CITY OF MANDAN, NORTH DAKOTA MAIN STREET WATER IMPROVEMENTS DISTRICT #39, WATER IMPROVEMENT PROJECT 96-2, PHASE III

Record Drawing

DATE: 2-14-97

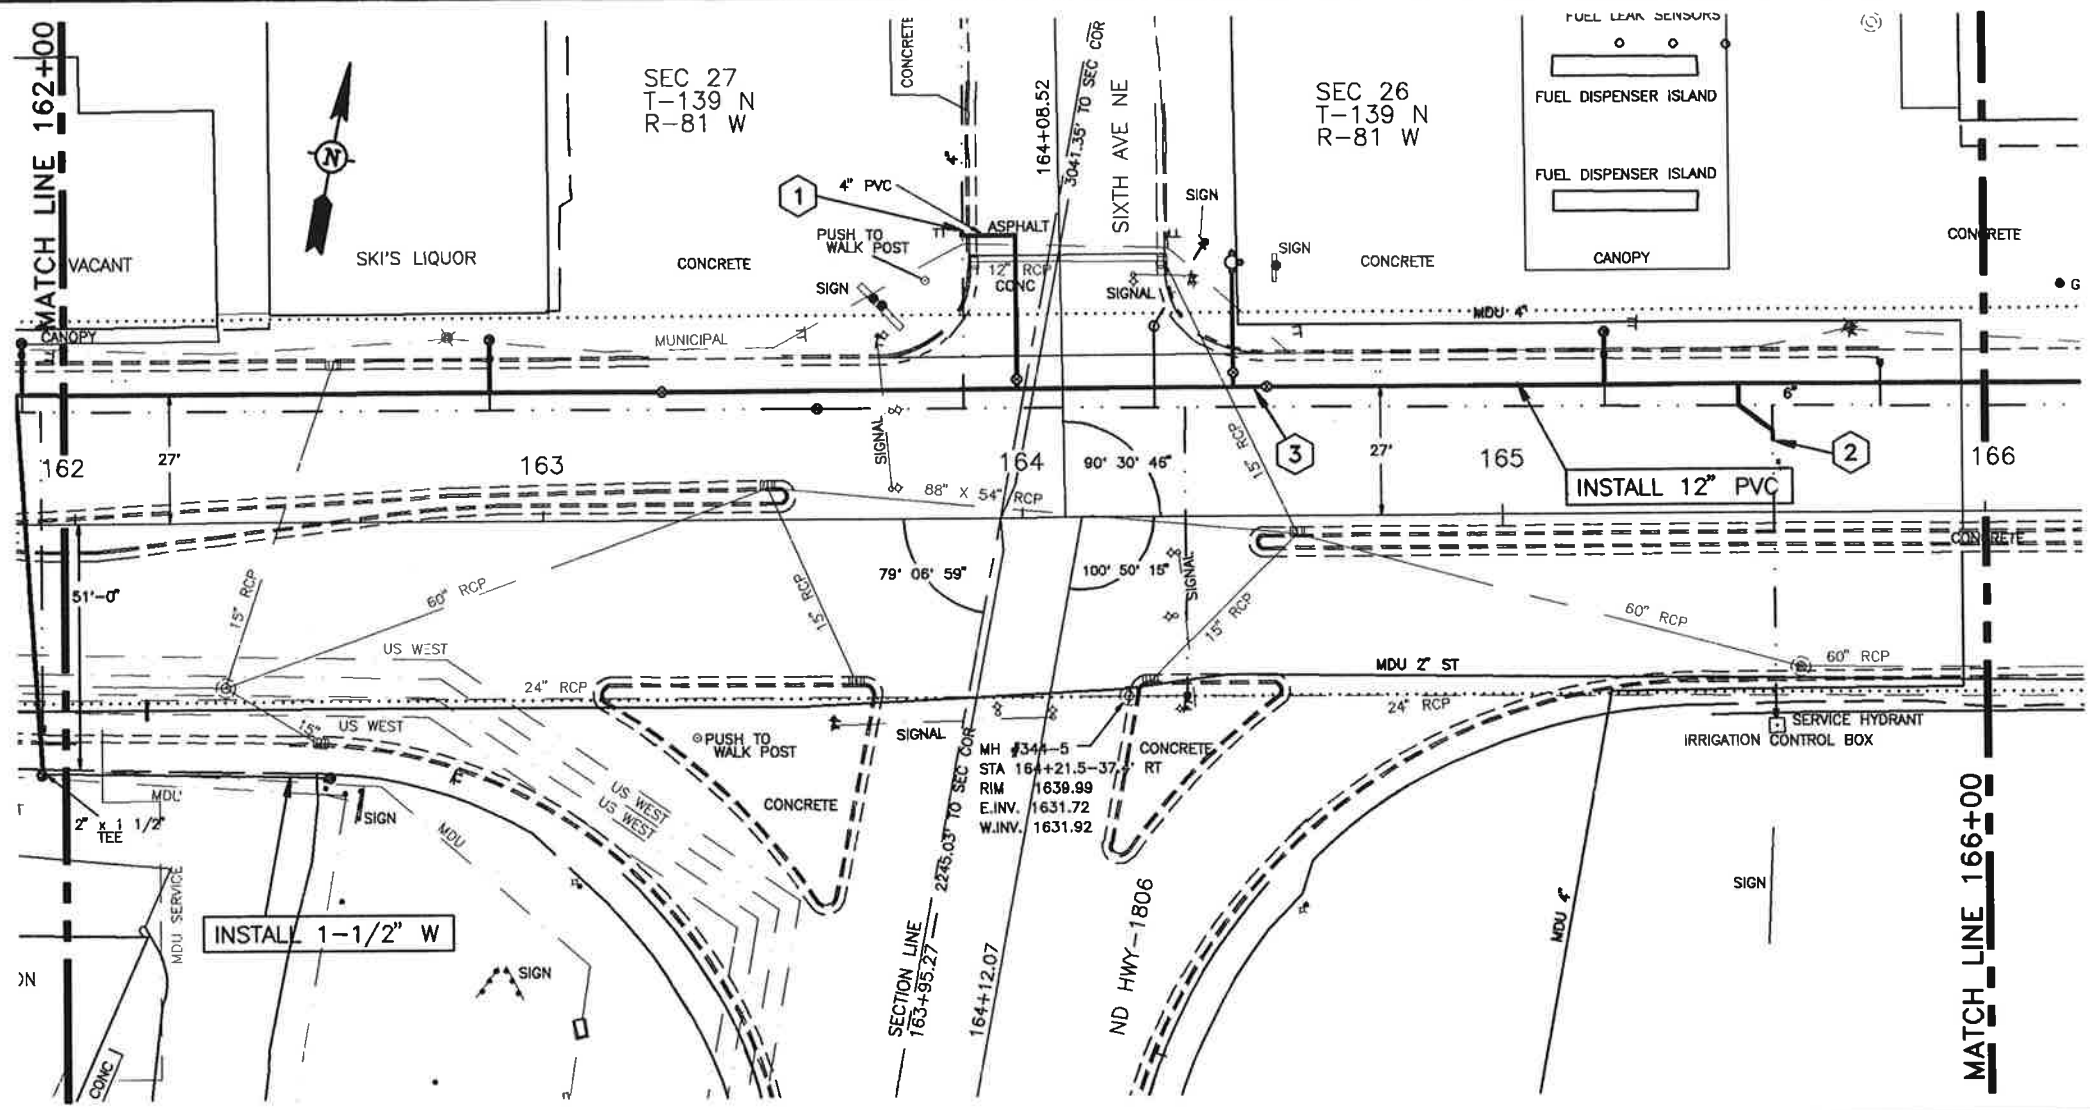
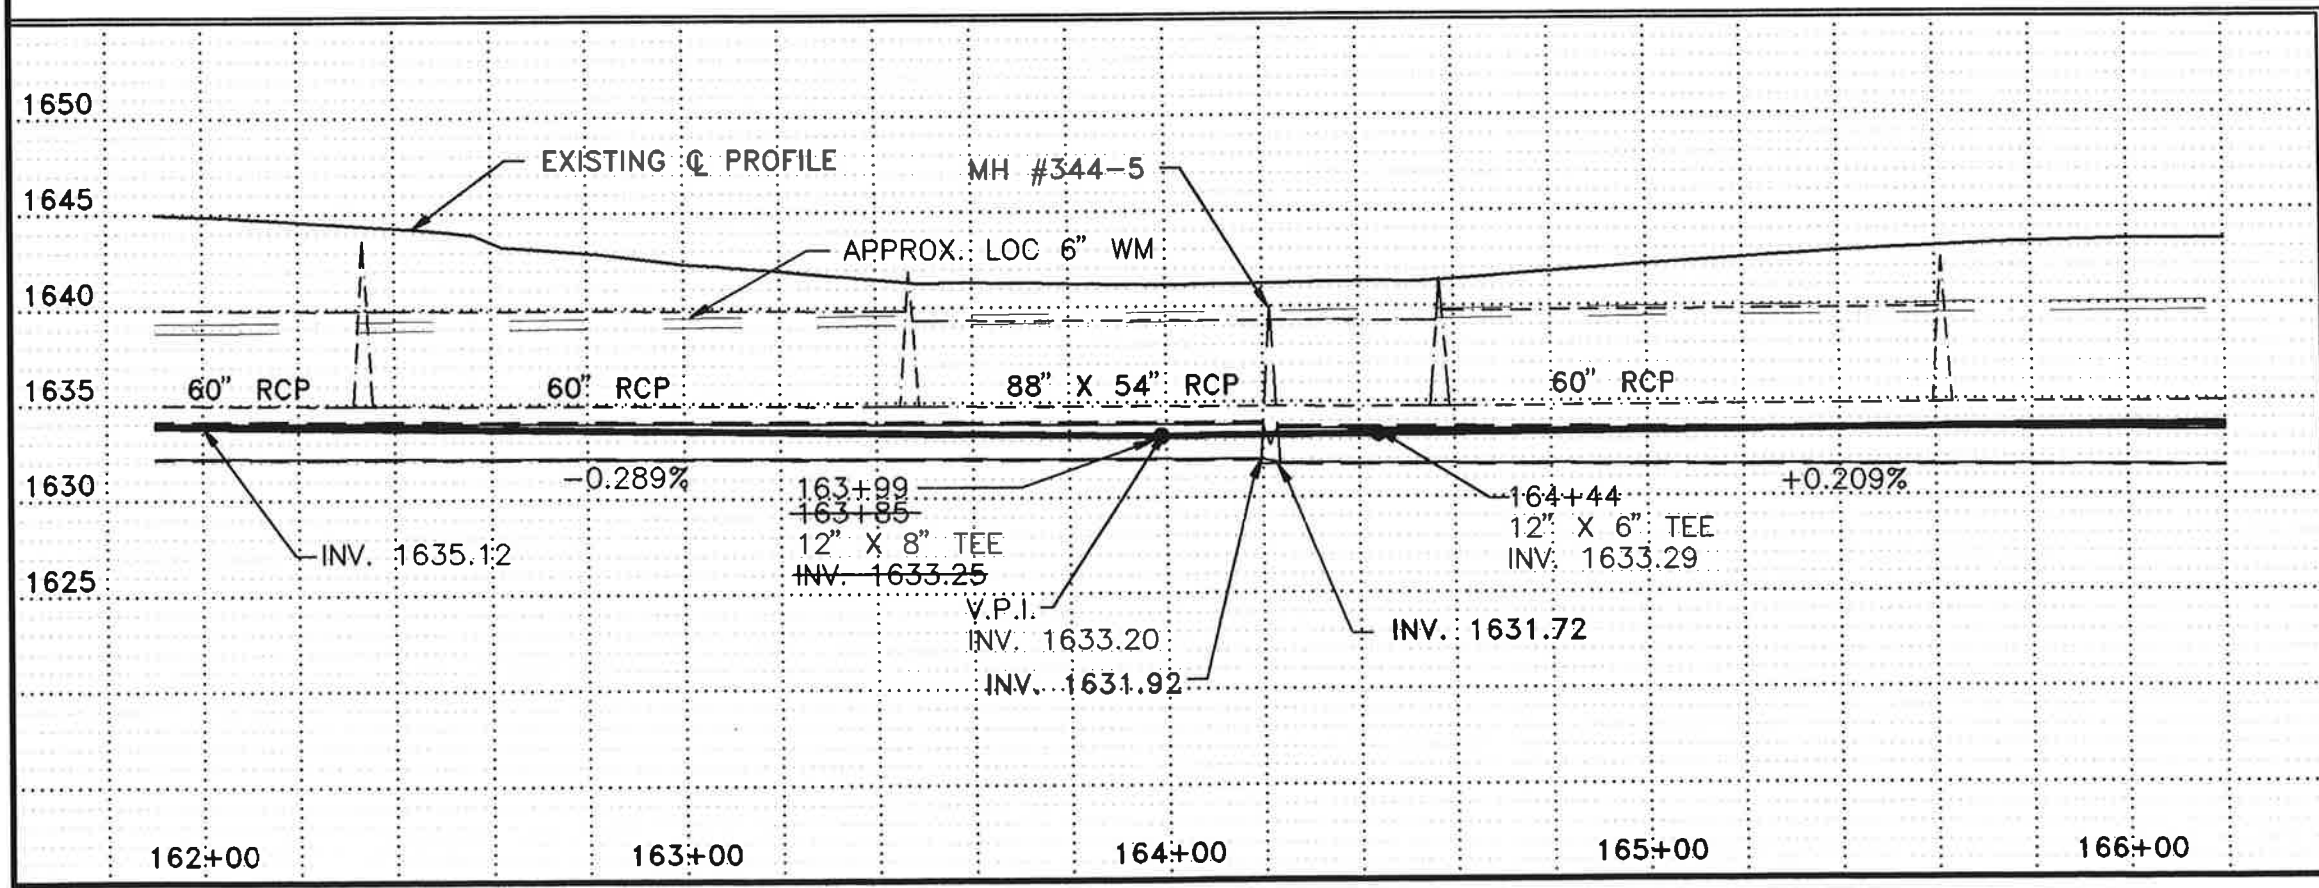
GATE VALVE AND BOX, 12"	
+51 164+48 - 27' LT	1 EA
WATERMAIN, 12" PVC	
+51 164+48 - 27' LT TO 166+00 - 27' LT	149+52 LF
FITTINGS, DUCTILE IRON	
+51 164+48 - 27' LT	12" PLUG 46-49 LBS
WATER SERVICE LINE 1-1/2" COPPER	
165+21 - 27' LT TO 165+21 - 38' LT	11 LF
+49 165+52 - 27' LT TO 165+52 - 15' 22' LT	12 -5 LF
WATER SERVICE CONNECTION	
165+21 - 27' LT	1 EA
+49 165+52 - 27' LT	1 EA
CURB STOP AND BOX 1-1/2"	
165+21 - 38' LT	1 EA

- CONSTRUCTION NOTES**
- ① CONNECTED
~~CONNECT~~ EXISTING 4" W.M. TO NEW 8" W.M.
 - ② CONNECTED
~~CONNECT~~ NEW 1-1/2" COPPER TO EXISTING 1" COPPER
 - ③ QUANTITIES FOR THIS PROJECT BEGIN AT 164+48⁺⁵¹ INSTALL 12" VALVE AND BOX AND PLUG IF PHASE II CONTRACTOR HAS NOT COMPLETED WORK IN THIS AREA. IF PHASE III CONTRACTOR HAS COMPLETED WORK IN THIS AREA, REMOVE PLUG AND CONNECT TO 12" WATERMAIN.

DRAWN BY: M.J.H.	SCALE: 1" = 40'	PROJECT NO. 95834
CHECKED BY: BPM	DATE: MAY 17, 1995	SHEET 9 of 20
APPROVED BY: BPM

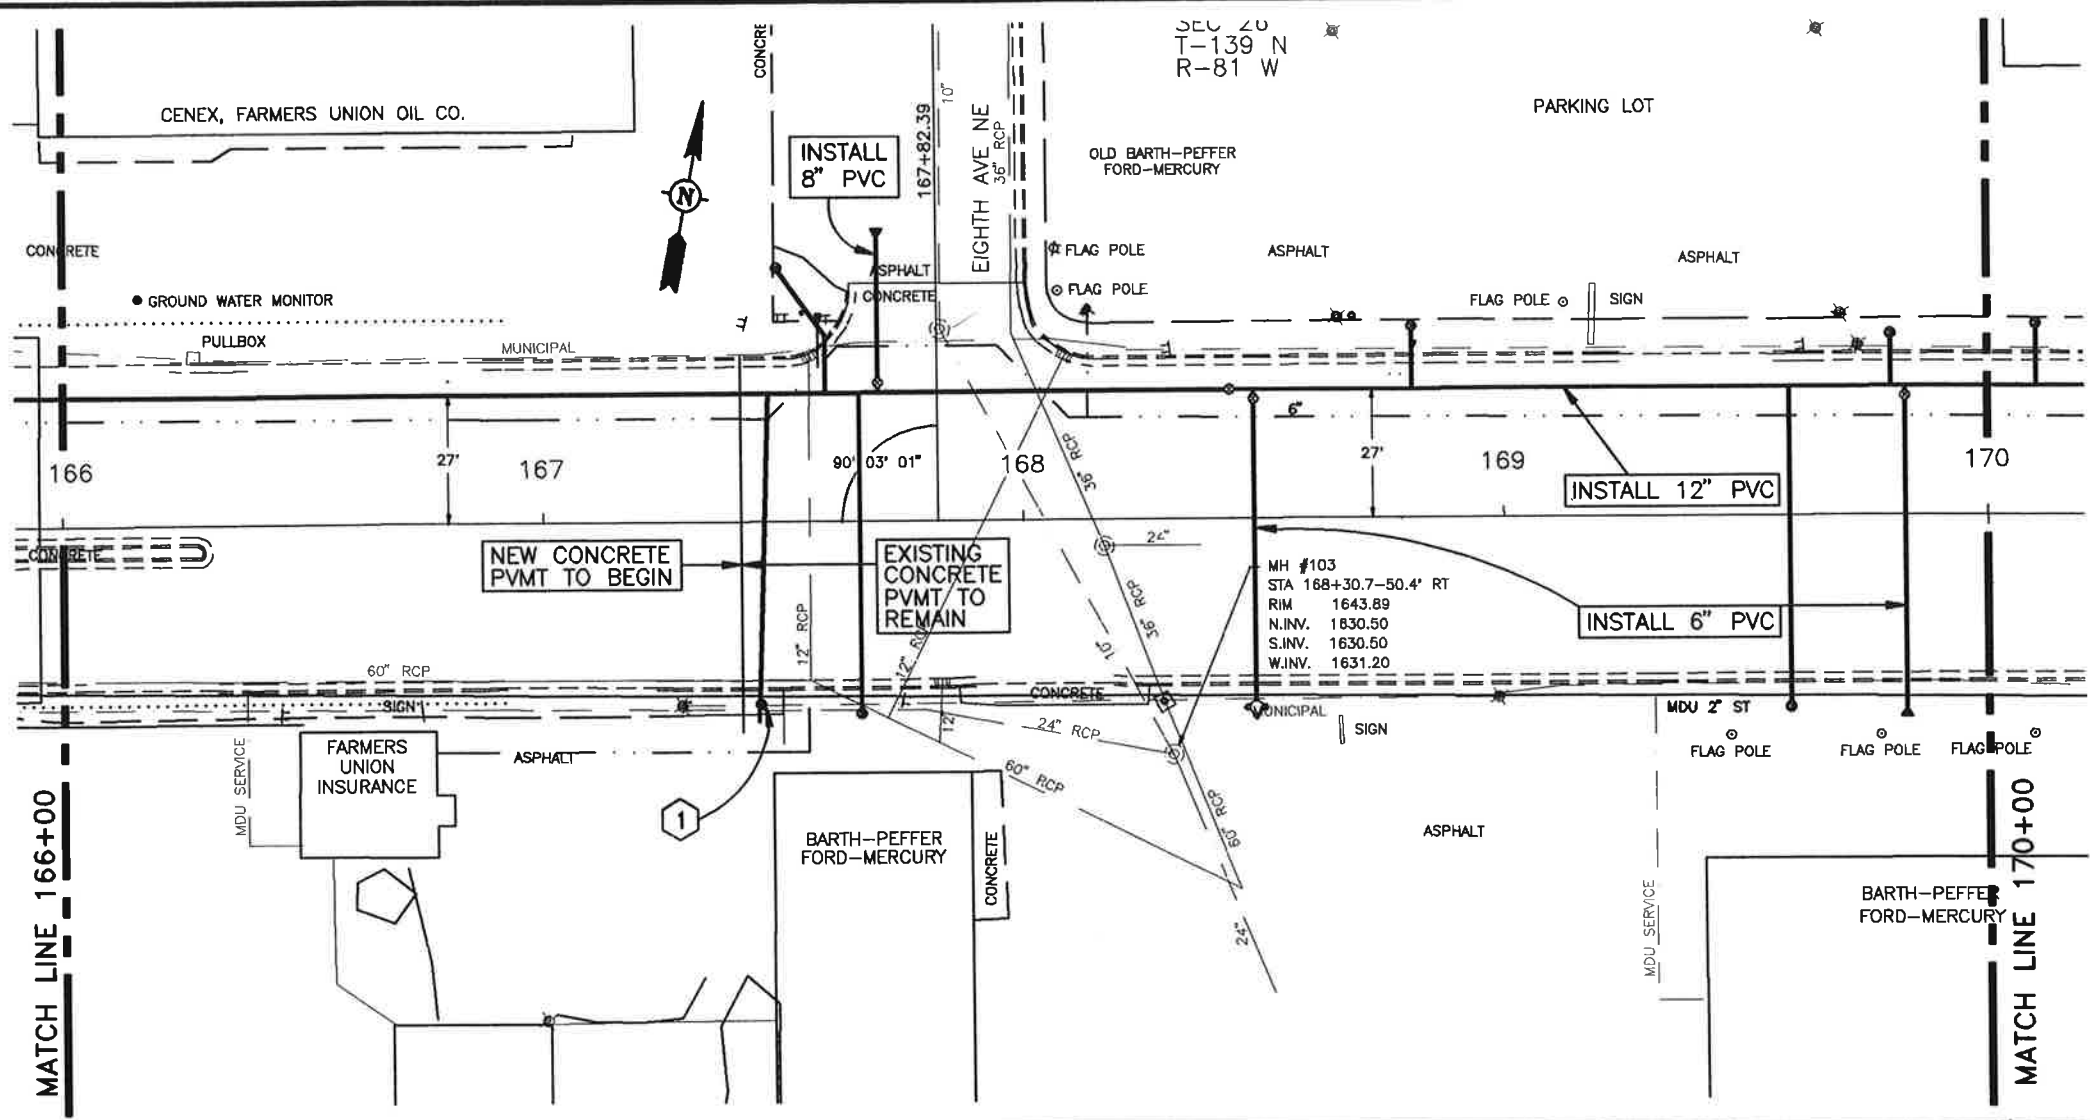
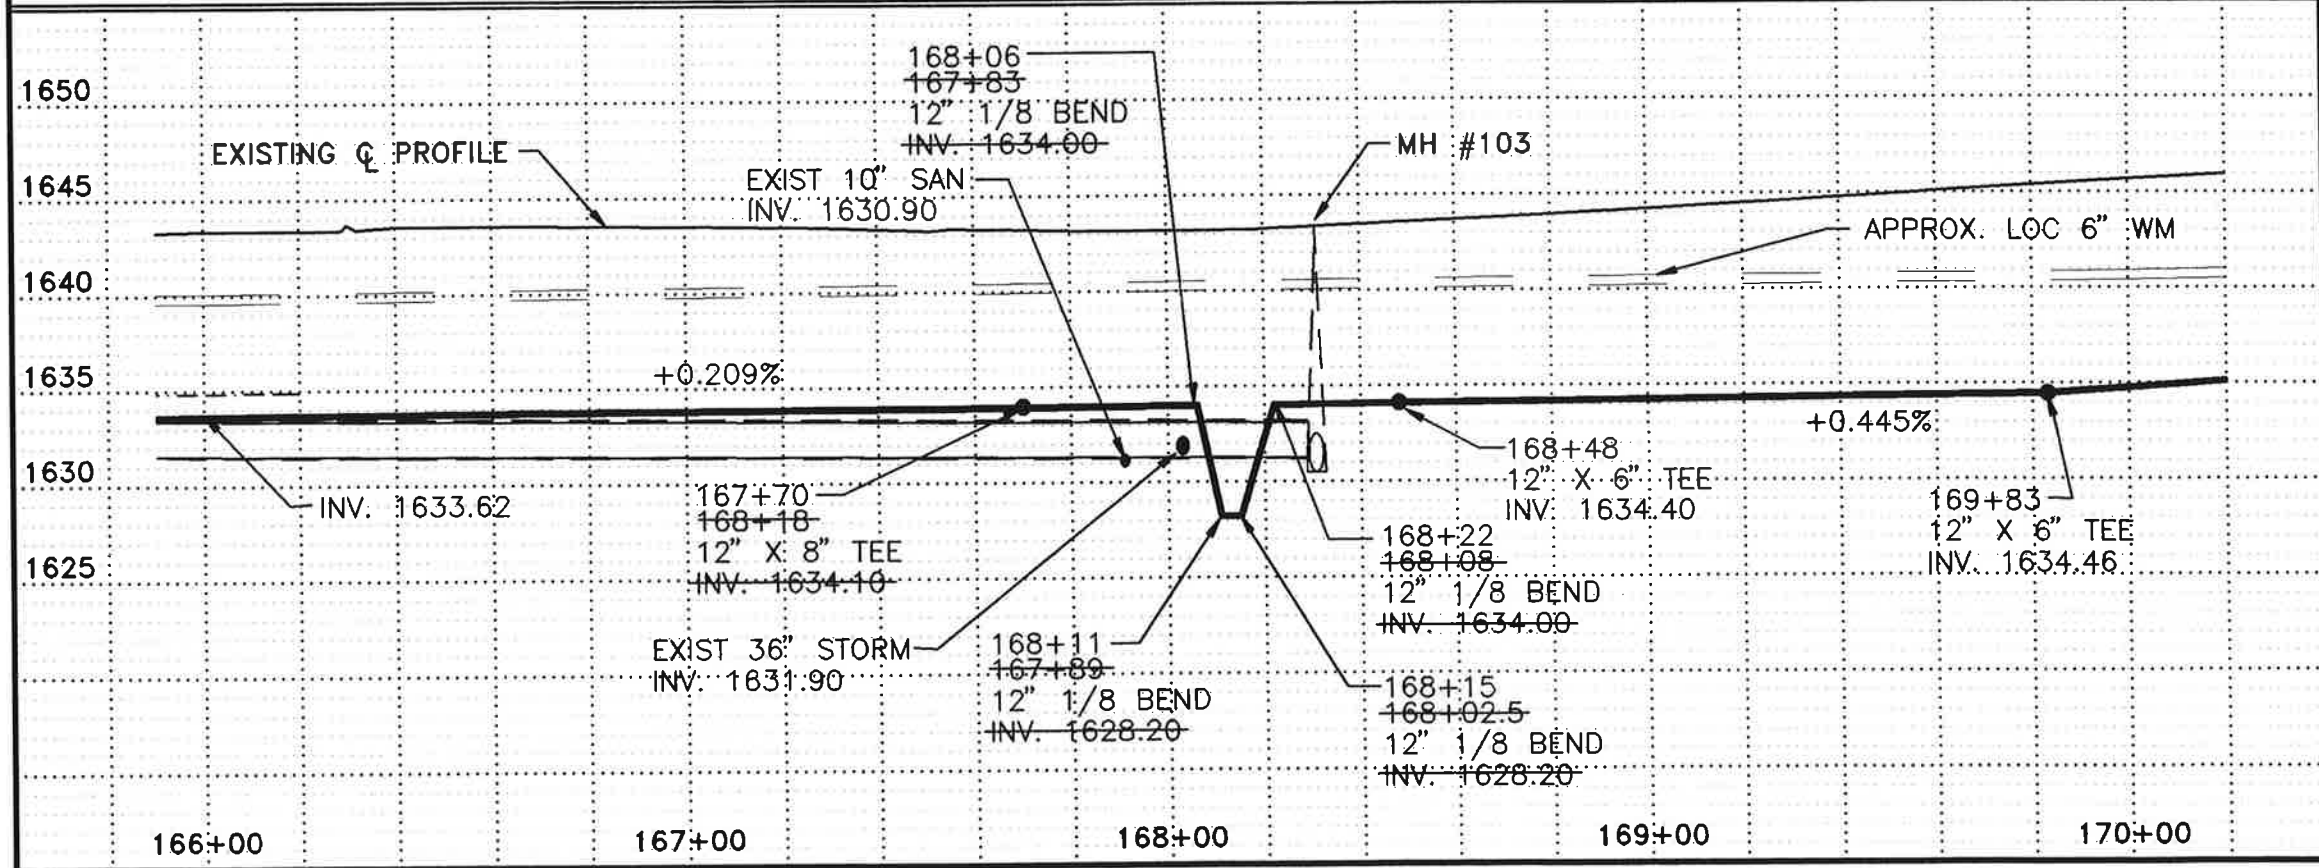
6" HYDRANT		
+48 168+45 - 39.5' RT	1 EA	
GATE VALVE AND BOX, 6"		
+48 168+45 - 25' 24' LT	1 EA	
169+83 - 25' 24' LT	1 EA	
GATE VALVE AND BOX, 8"		
167+70 - 168+18 - 29' 30' LT	1 EA	
GATE VALVE AND BOX, 12"		
+48 168+42 - 27' LT	1 EA	
WATERMAIN, 6" PVC		
+48 168+45 - 27' LT TO 168+45 - 39.5' RT	66.5 LF	
169+83 - 27' LT TO 169+83 - 40' RT	67 LF	
WATERMAIN, 8" PVC		
167+70 - 168+18 - 27' LT TO 168+18 - 59' 60" LT	32 33 LF	
WATERMAIN, 12" PVC		
166+00 - 27' LT TO 170+00 - 27' LT	400 LF	
FITTINGS, DUCTILE IRON		
168+06 - 167+83 - 27' LT	12" 1/8 BEND	111 92 LBS
168+11 - 167+89 - 27' LT	12" 1/8 BEND	111 92 LBS
+19 168+02.5 - 27' LT	12" 1/8 BEND	111 92 LBS
+22 168+08 - 27' LT	12" 1/8 BEND	111 92 LBS
167+70 - 168+18 - 27' LT	12" X 8" TEE	123+37 LBS
167+70 - 168+18 - 59' 60" LT	8" PLUG	26 LBS
+48 168+45 - 27' LT	12" X 6" TEE	115+23 LBS
169+83 - 27' LT	12" X 6" TEE	115+23 LBS
169+83 - 40' RT	6" PLUG	15 LBS
WATER SERVICE LINE 1-1/2" COPPER

+47 167+45 - 27' LT TO 167+45 - 38' RT	26 66 LF	
+59 167+58 - 27' LT TO 167+58 - 53' 45" LT	13 18 LF	
168+81 - 27' LT TO 168+81 - 40' 38" LT	11 LF	
169+80 - 27' LT TO 169+80 - 40' LT	13 LF	
169+59 - 27' LT TO 169+59 - 40' RT	13' LF	
167+66 - 27' LT TO 167+66 - 40' RT	13' LF	
WATER SERVICE CONNECTION		
+47 167+45 - 27' LT	1 EA	
+59 167+58 - 27' LT	1 EA	
168+81 - 27' LT	1 EA	
169+80 - 27' LT	1 EA	
167+66 - 27' LT	1 EA	
CURB STOP AND BOX 1-1/2"		
+47 167+45 - 38' RT	1 EA	
+49 167+58 - 53' 45" LT	1 EA	
168+81 - 40' 38" LT	1 EA	
169+80 - 40' LT	1 EA	
169+59 - 40' RT	1 EA	
167+66 - 40' RT	1 EA	
REMOVE HYDRANT		
168+42 - 43' LT	1 EA

REMOVE HYDRANT		
168+42 - 43' LT	1 EA	
CONSTRUCTION NOTES		
1	CONNECTED	
	CONNECT NEW 1-1/2" COPPER	
	TO EXISTING SERVICE LINE
